CONSTRUCTION SUMMARY OF EXTRAS
Printed 2022-03-01 / 4:31 PM / Page 1 of 1

CALEDON (B)
191-2
JASPER (RLTH-03) ELEV C Op ground fir 4 bed
Jaspreet Kaur Randhawa
Gulbir Kaur Randhawa
416-5619418 Agent 416 670-4655
jass2101@yahoo.ca

ZANCOR HOMES COLOUR CHART

JASPER RLTH-03

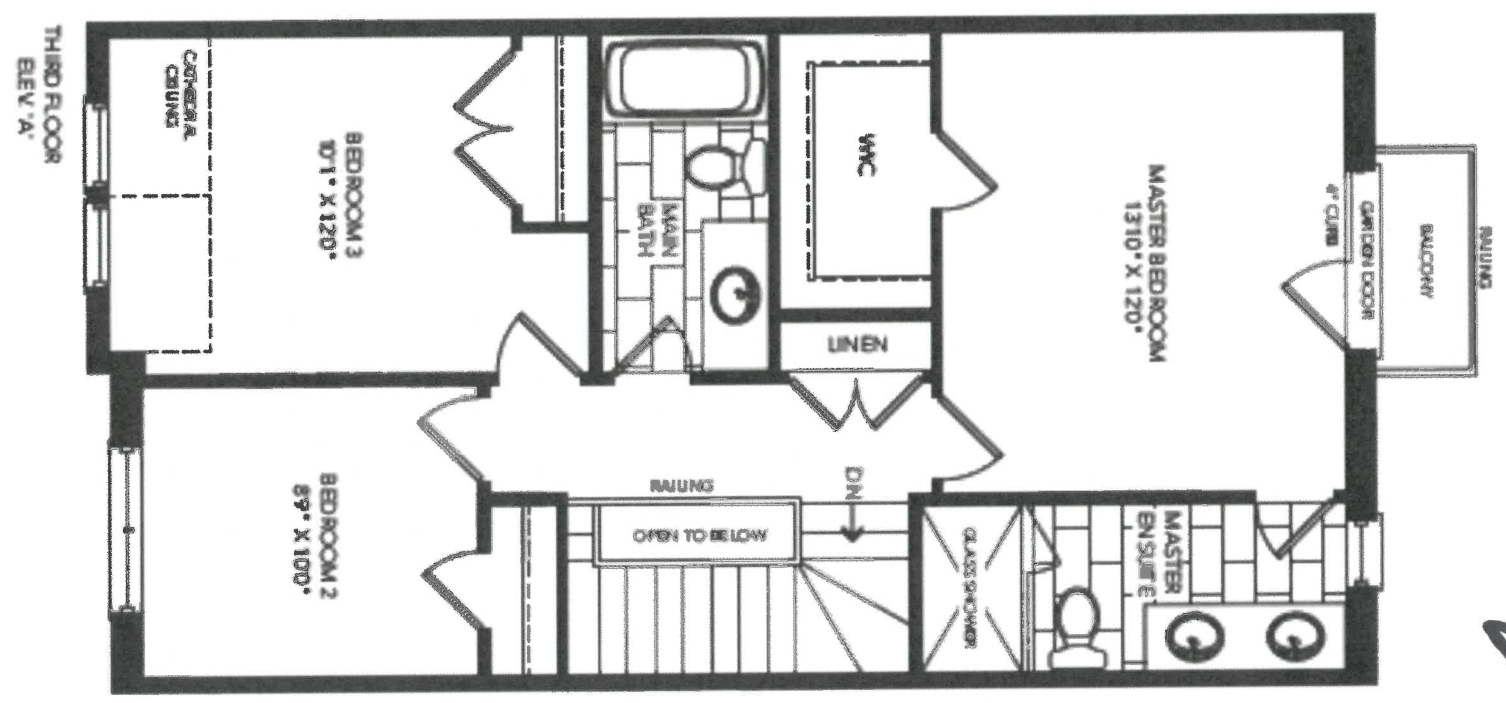
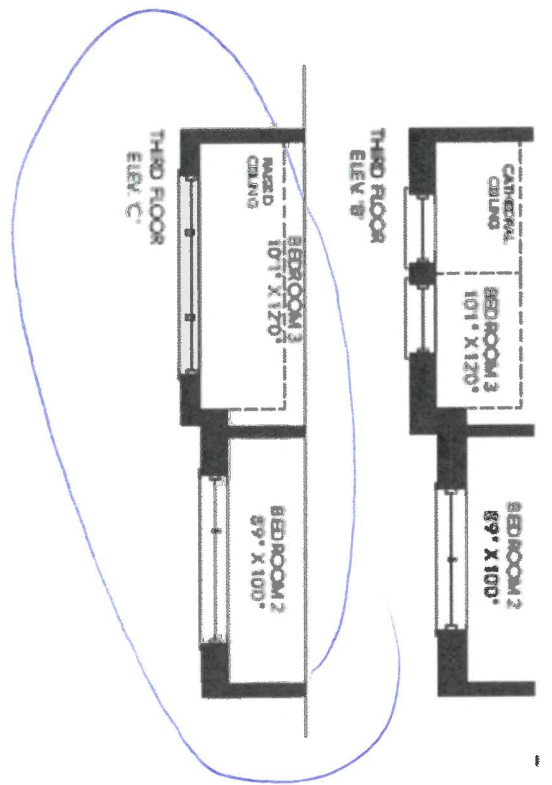
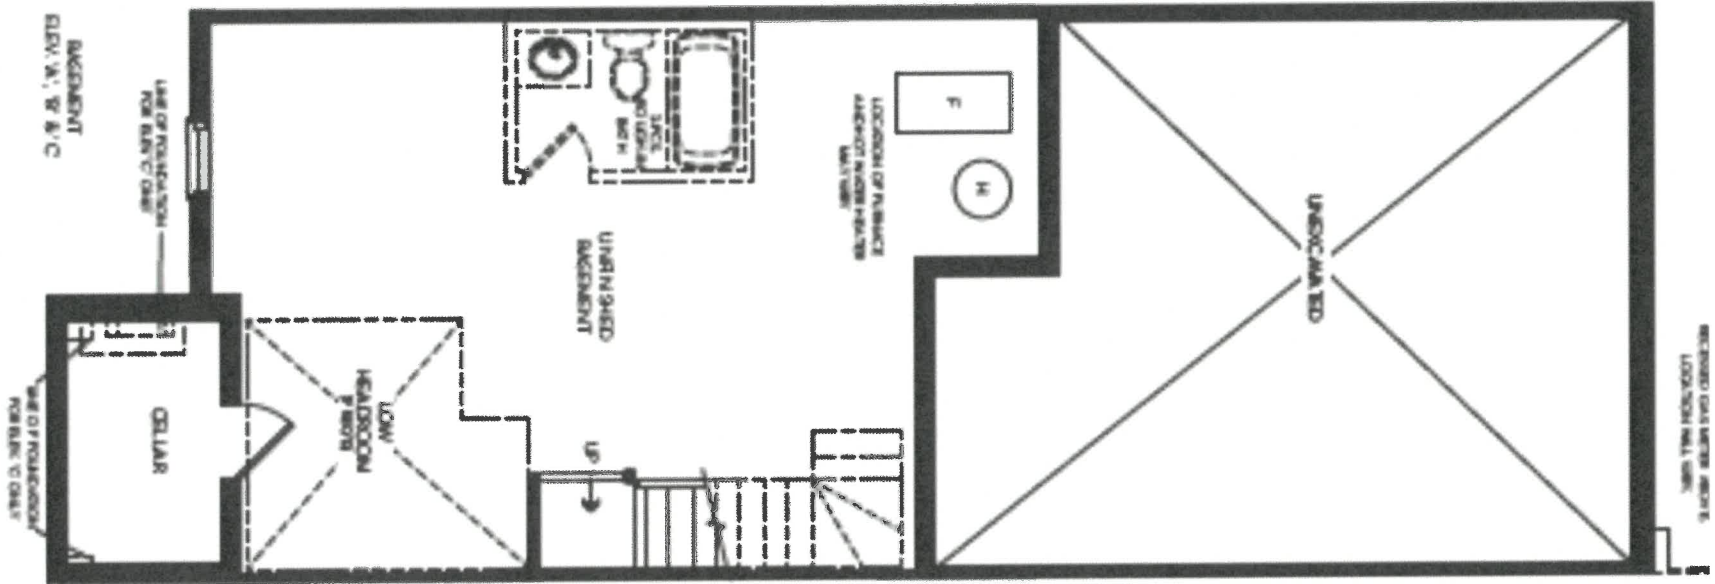
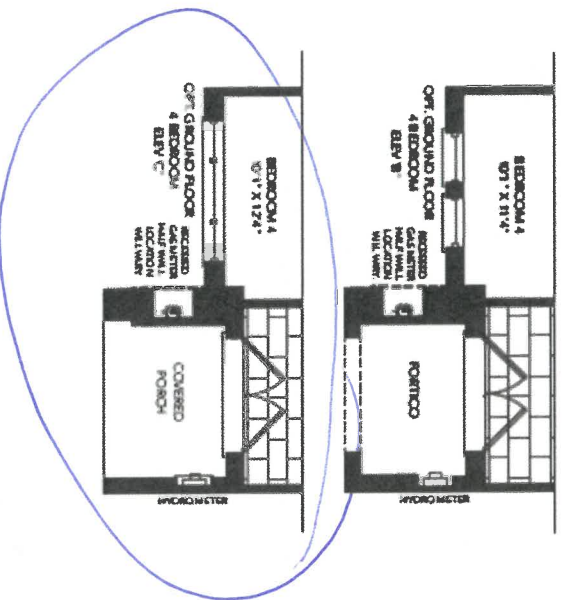
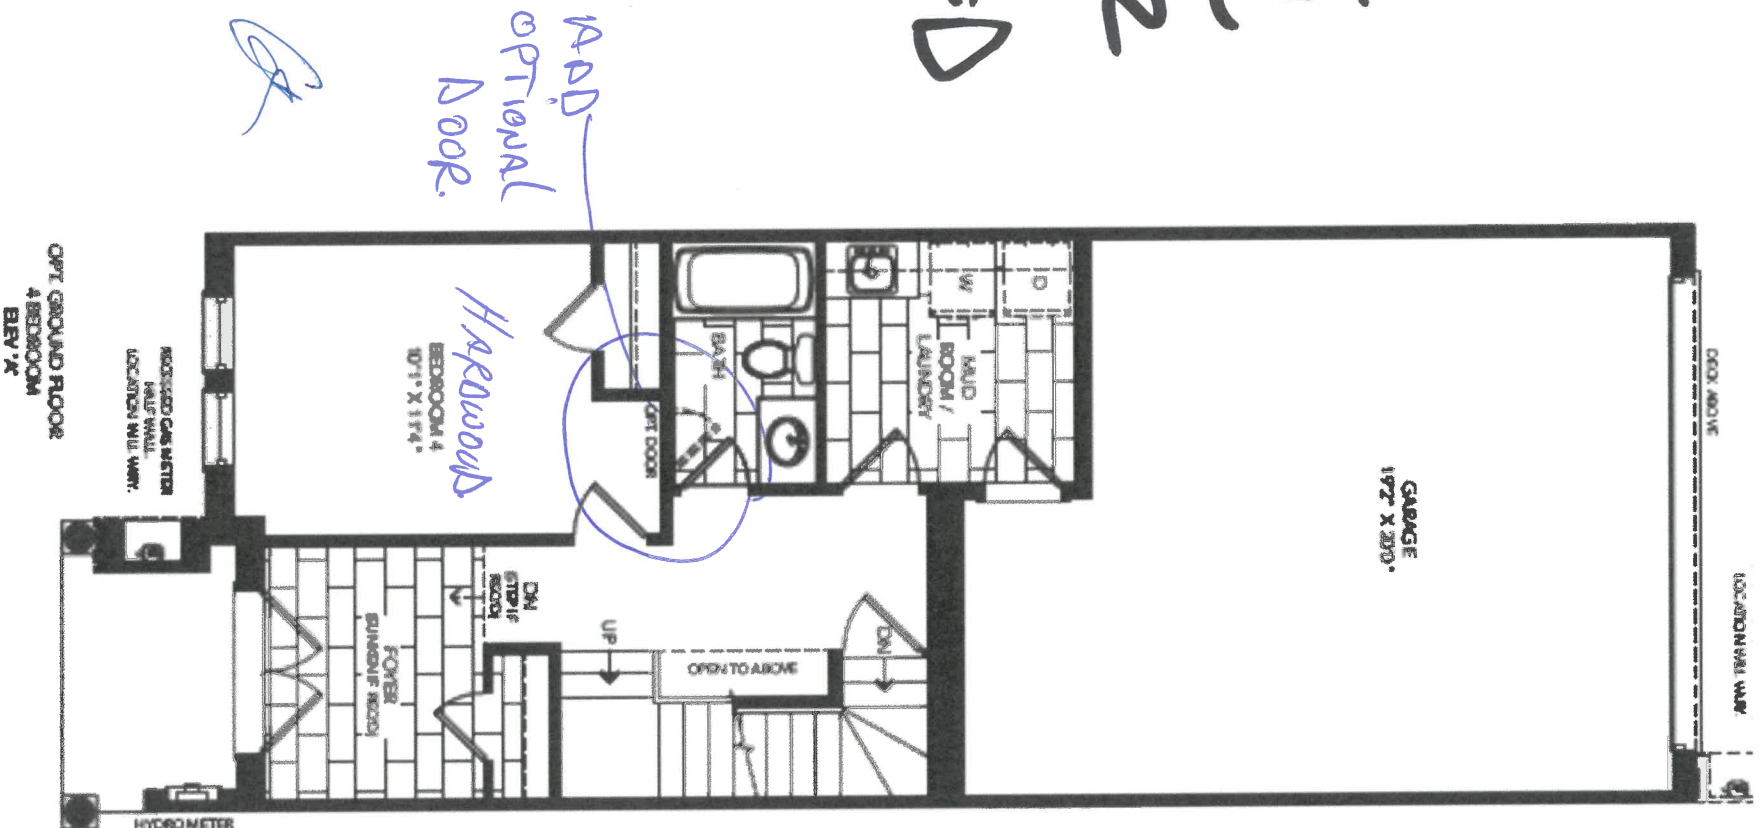
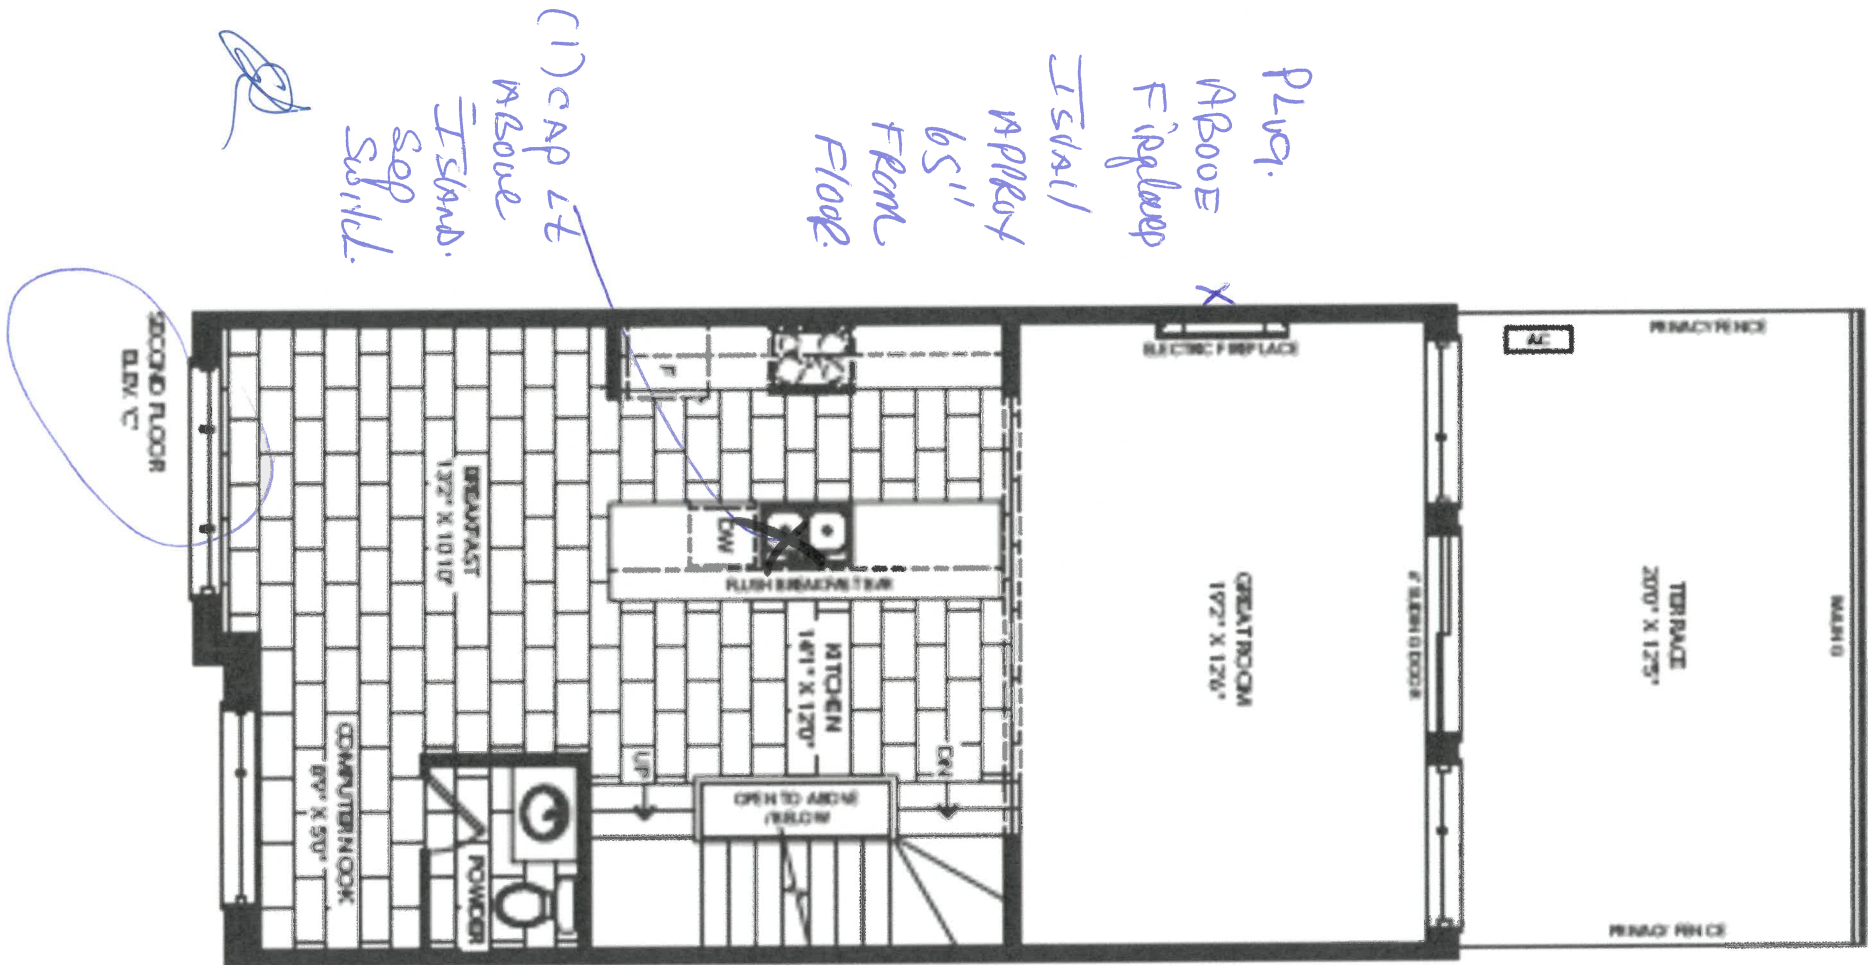
| DESCRIPTION | | DATE SELECTED |
|-----------------------------------------------------------------------------|------------------------------------------------------------------------|-----------------|
| 1 | ADD PLUG ABOVE FIREPLACE INSTALL APPROX 65" FROM FLOOR | 18-Feb-22 |
| 2 | (1) CAPPED LIGHT ON SEPARATE SWITCH ABOVE KITCHEN ISLAND | 18-Feb-22 |
| 3 | WATERLINE TO FRIDGE | 18-Feb-22 |
| 9 | ADD OPTIONAL DOOR GROUND FLOOR BEDROOM 4 | 18-Feb-22 |
